Planning and Zoning Commission

October 6, 2020

TO: Planning and Zoning Commission
FROM: Evann Martin, Assistant Planner
DATE: October 6, 2020
RE: Destination Market Plat 5 – Preliminary Plat

RE: Destination Market Plat 5 Lot 1 Coffee Shop – Site Plan

GRADING PLAN

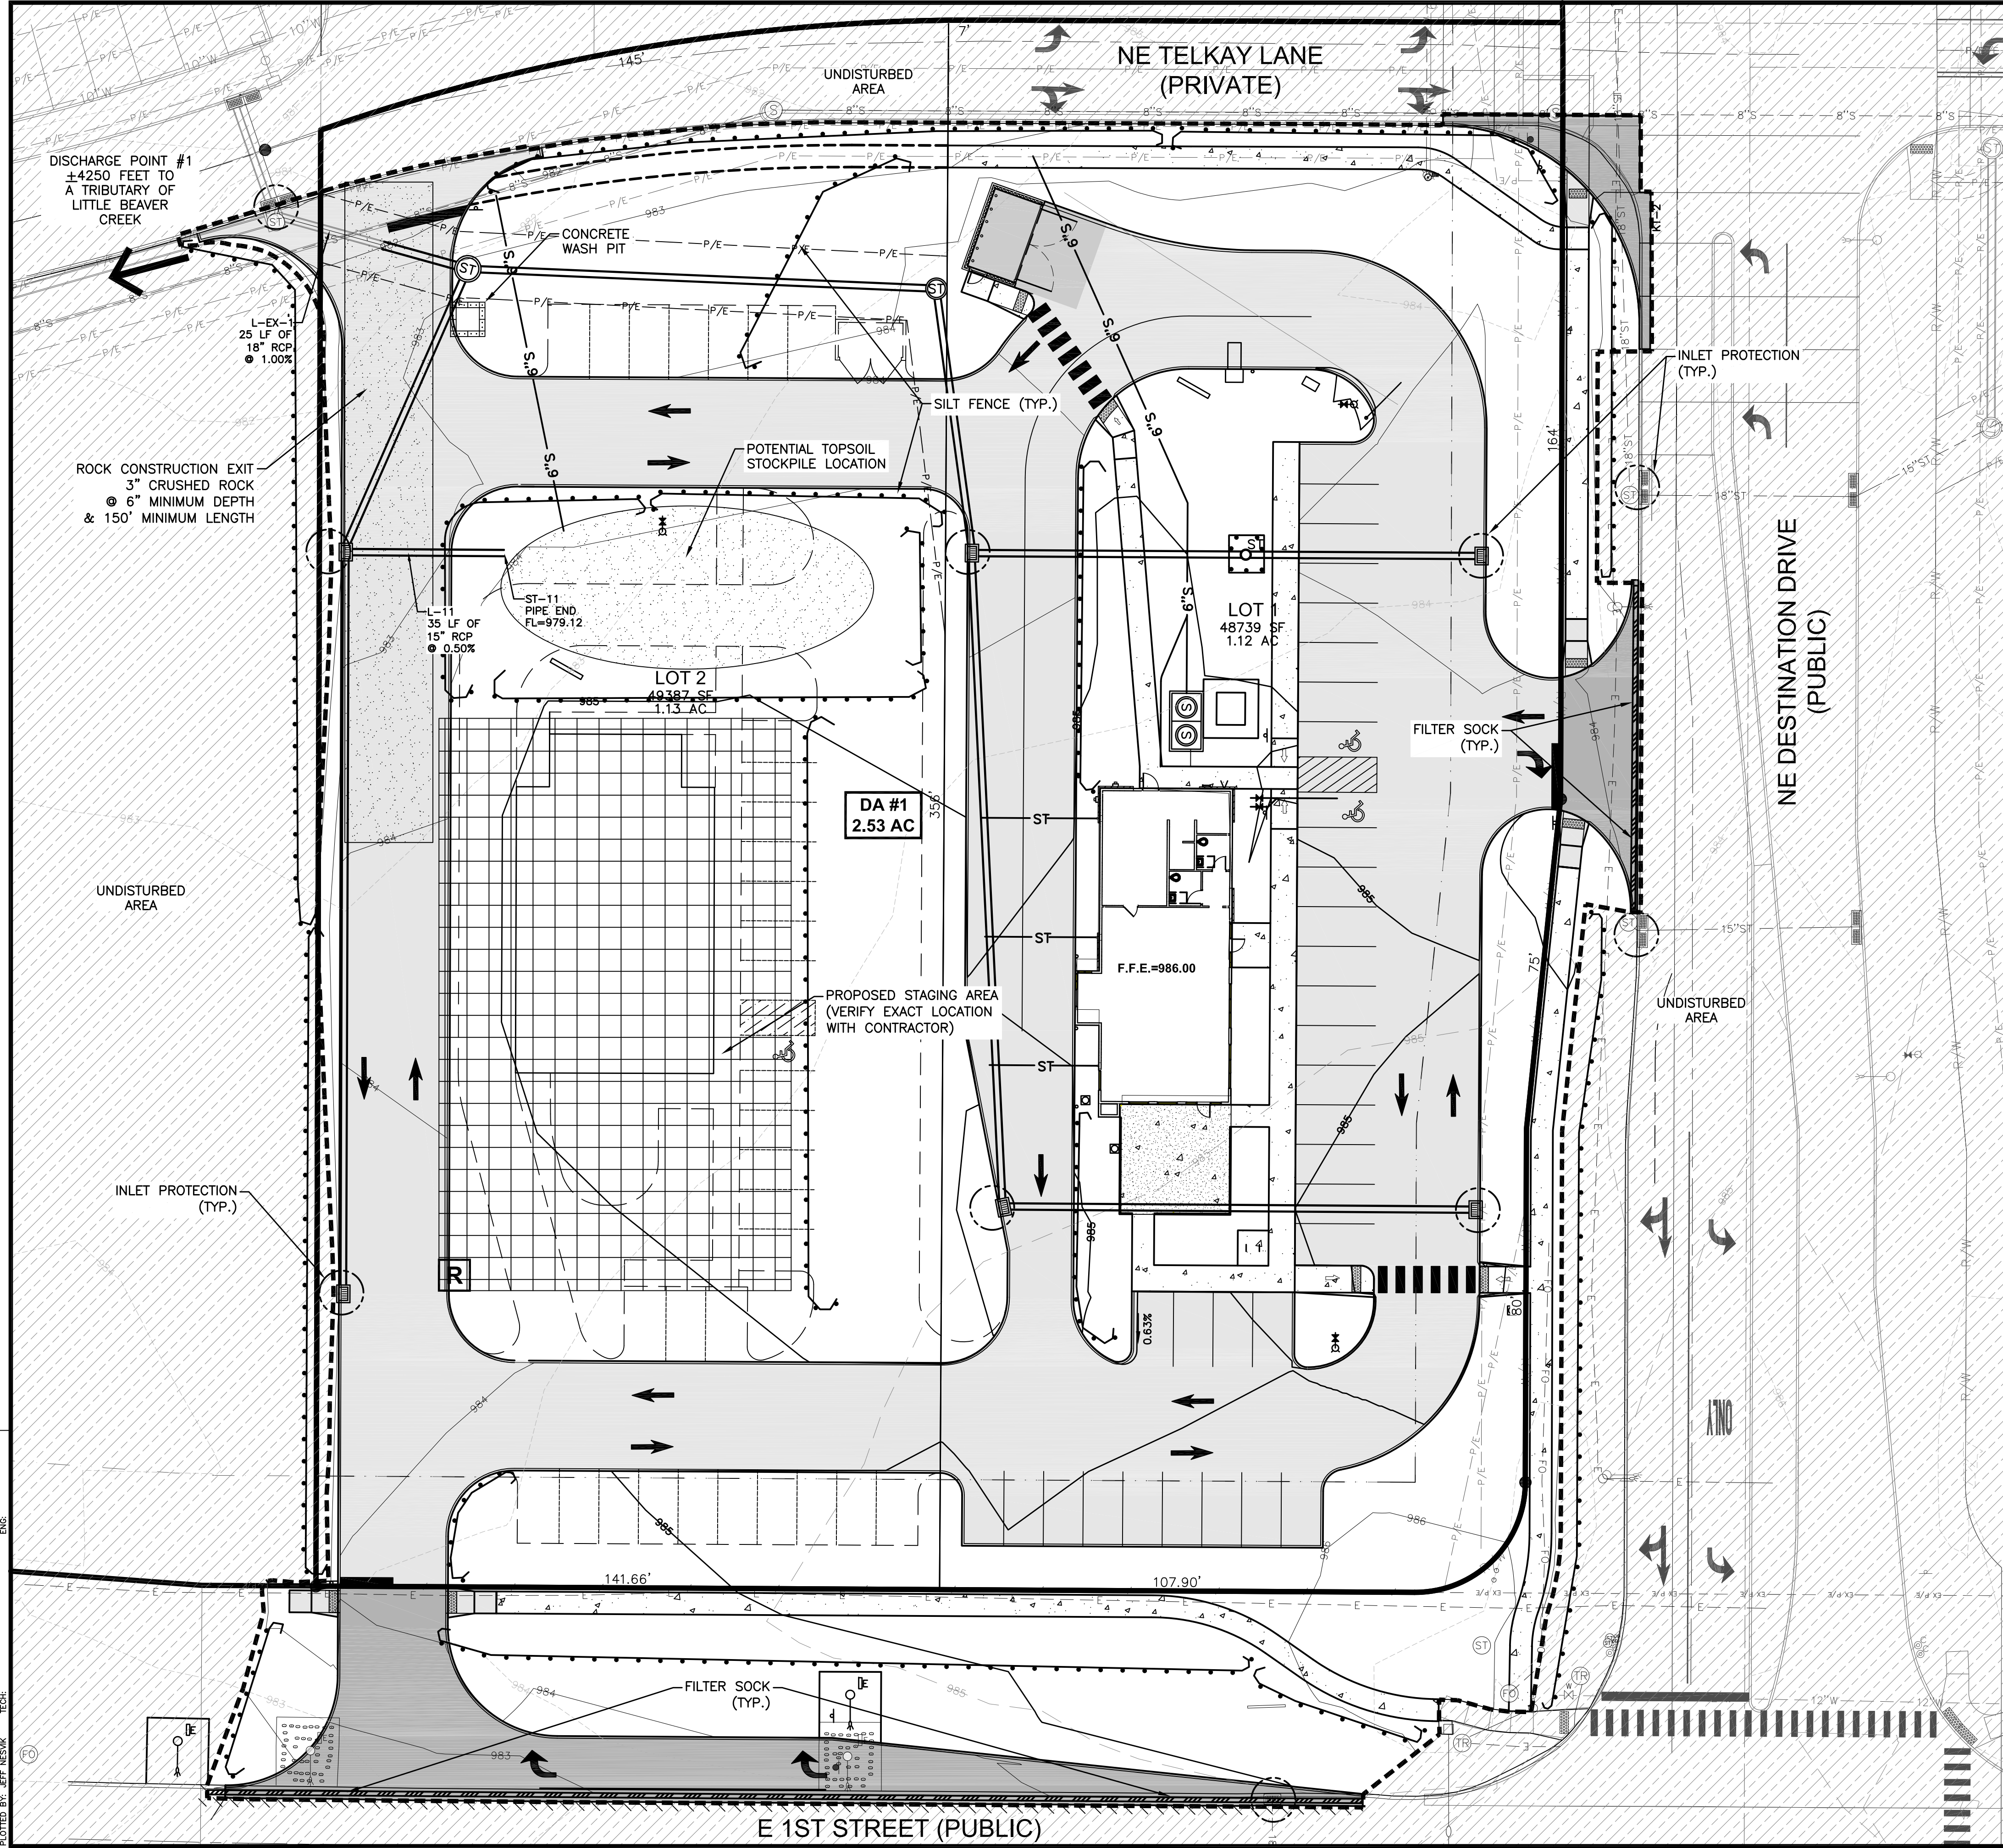
3. ~~Sheet 4/8:~~

- ~~○ Near ST 4, TC=984.13 on sheet 4 and TC=984.48 on sheet 6 and said spots are only feet apart. Please rectify at this location and others. Spots were not reviewed across the entire site.~~
- ~~○ Identify and rectify either grading issues or label issues at TC/FG. Across from ST 4 is a spot showing TC=985.45 and FG=983.77 which exceeds a 0.5' curb height. Please rectify at this location and others. Spots were not reviewed across the entire site.~~
- ~~○ Update slope arrow (currently 1.36% the wrong direction) when the FG surface is updated.~~

UTILITY PLAN

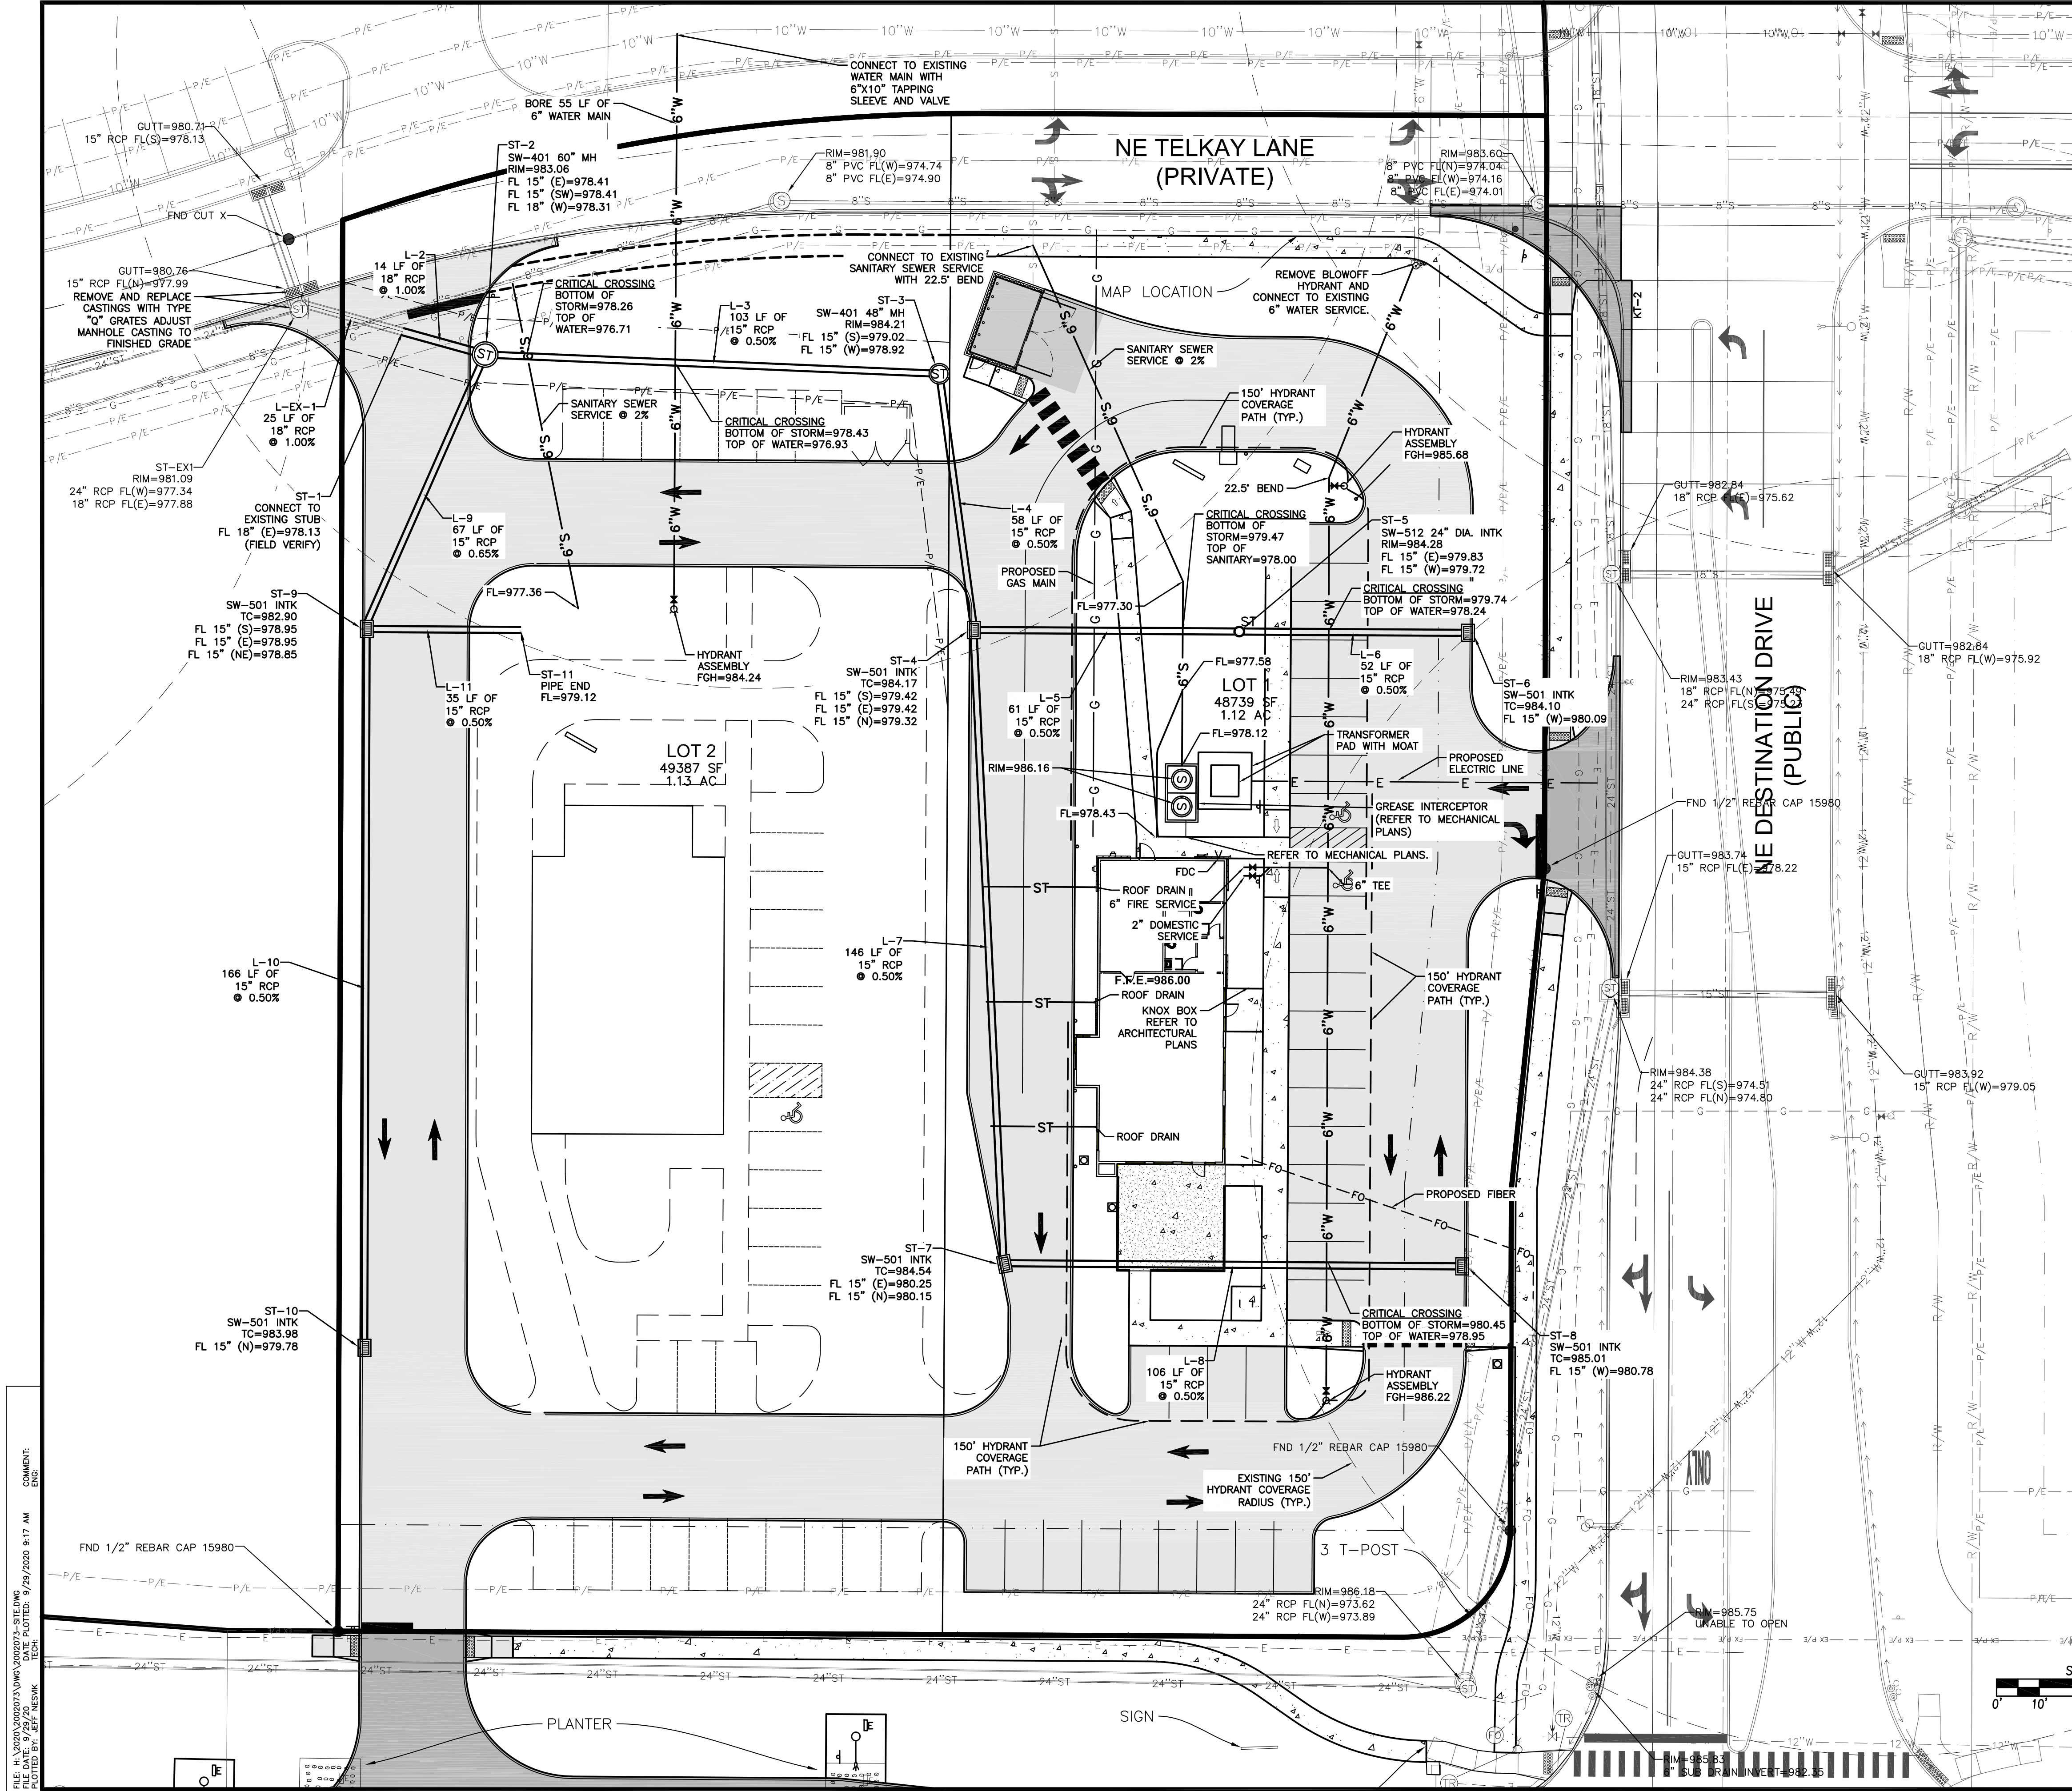
- ~~1. Change tapping assembly to Tapping Sleeve & Valve after 6x10 note.~~
- ~~2. Follow SUDAS Specifications, use C-4 mix with 4" slump max. and 8% air with paver and 7% for hand placement.~~

- ~~5. The fire department connection for the fire sprinkler system is not shown on the plan. Note that per Section 912.4.2 of the City of Grimes Fire Code should the FDC be placed near parking, the space directly in front of the FDC shall be marked "No Parking." The FDC shall also be placed within 100 feet of a fire hydrant per Section 507.5.1.1. The current FDC location would require a stripped parking space in front of the FDC. If the FDC were located near the handicap spaces, or if the handicap spaces were moved near the FDC, the site would be in compliance.~~

5. ~~Sheet 6/8:~~

- ~~○ Rectify backslope on Pipe L-11 and update associated information on SWMP tables. The slopes do not match.~~
- ~~○ Verify Pipe L-2 length (14' SWMP vs. 18' SP)~~
- ~~○ Verify Pipe L-EX1 and structure ST-EX1 inverts, slopes, and lengths. SP and SWMP pages 15 & 16 have conflicting data. Please label said pipe and structure on the SP.~~
- ~~○ ST 5 is shallow and violates guidance provided by SUDAS Figure 6010.512. Verify construction of structure with owner and contractor. The City is okay with the structure as proposed.~~
